Periodic Review Checklist

Table of SMP Changes

Draft August 1, 2018

Exhibit 1. Rezoning Map of the Barbee Mill Site

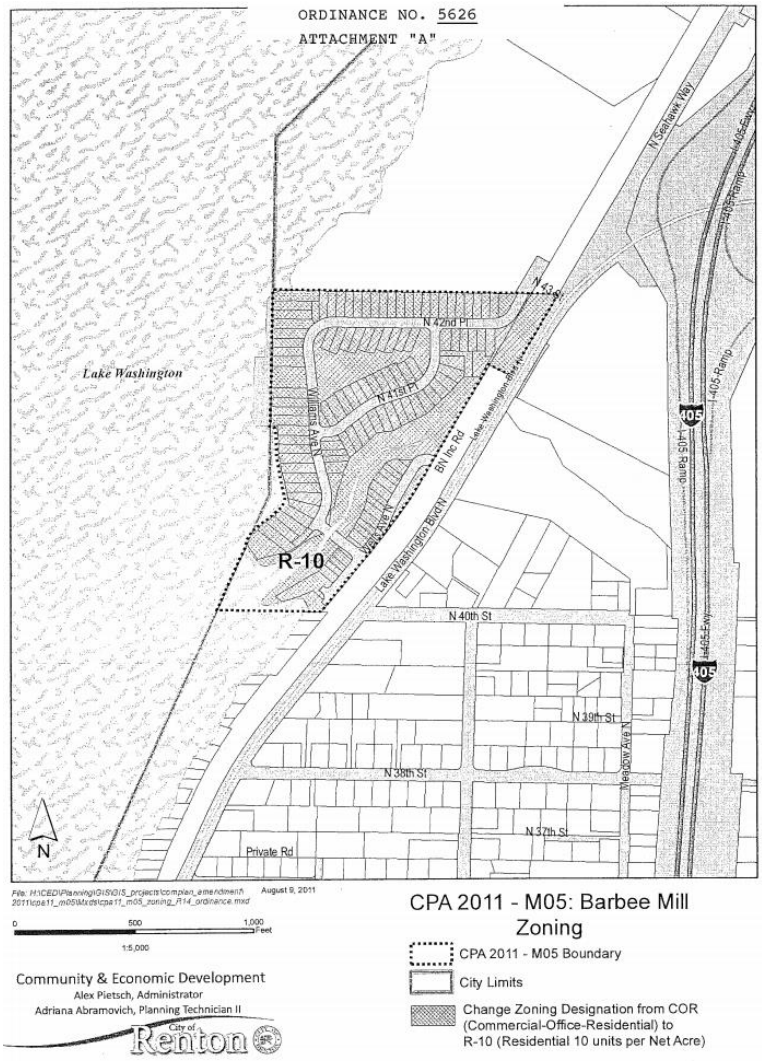
One of the propsed changes to the SMP includes an environment redesignation at the Barbee Mill site. In 2011, Renton City Council approved a Comprehensive Plan change (Ordinance 5624) resdesignating the site from COR (Commercial Office Residential) land use to HD (Residential High Density). They also approved a rezone for the site from COR to R-10 (Residential 10) zoning (Ordinance 5626), shown in Exhibit 1 .

Boundaries: Exhibit 2 illustrates the current High Intensity designation. The boundaries of the property in Exhibit 1 more closely indicate the property that would change from High Intensity to Shoreline Residential.

Exhibit 2. 2011 Shoreline Environment Designation for the Barbee Mill Site

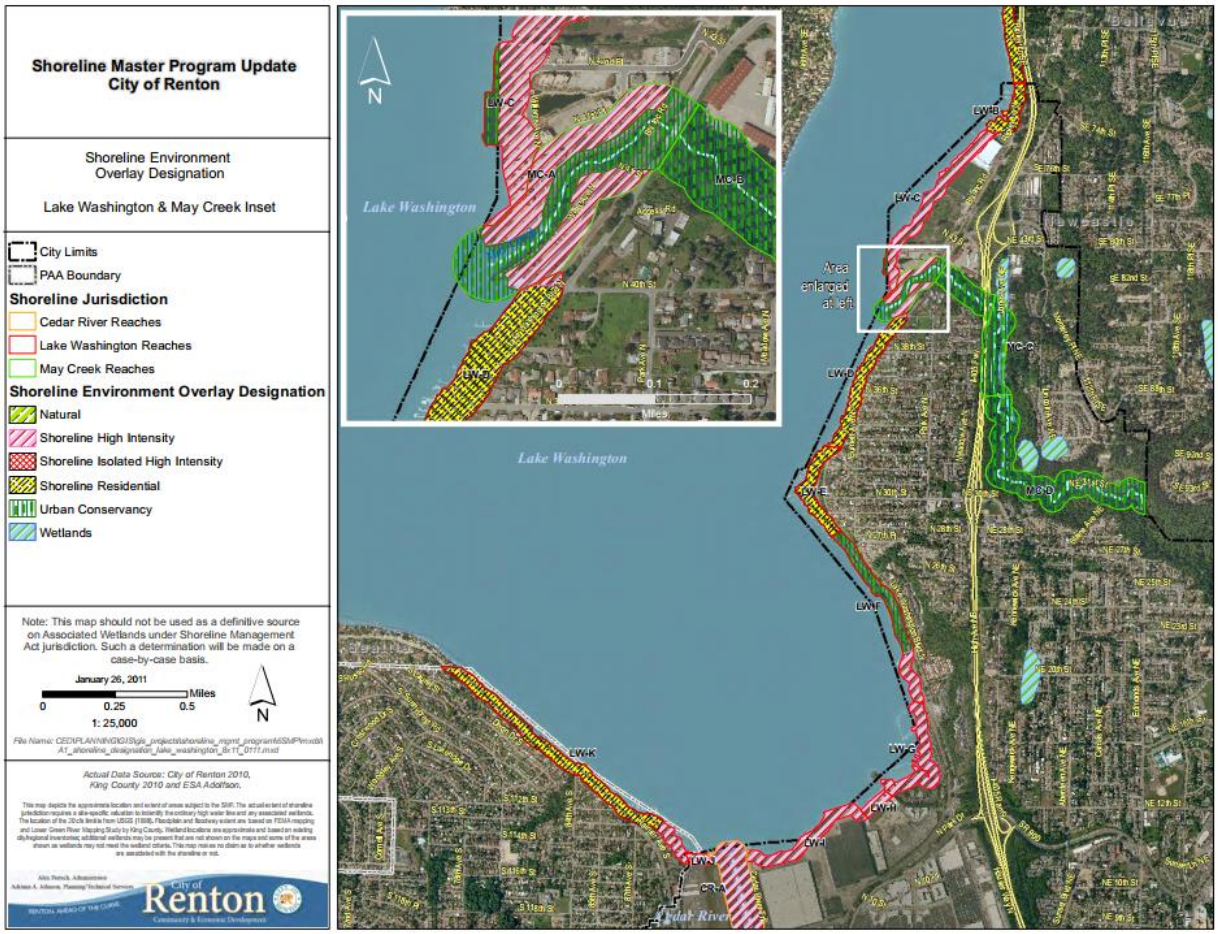
The SMP was adopted in 2011 prior to the City's approval of the development agreement, land use designation change, or rezone of the property. In the adopted SMP, developable portions of the Barbee Mill site were designated as a Shoreline High Intensity Environment (see Exhibit 2) .[1] This matched the COR land use and zoning designation of that site at the time of adoption.
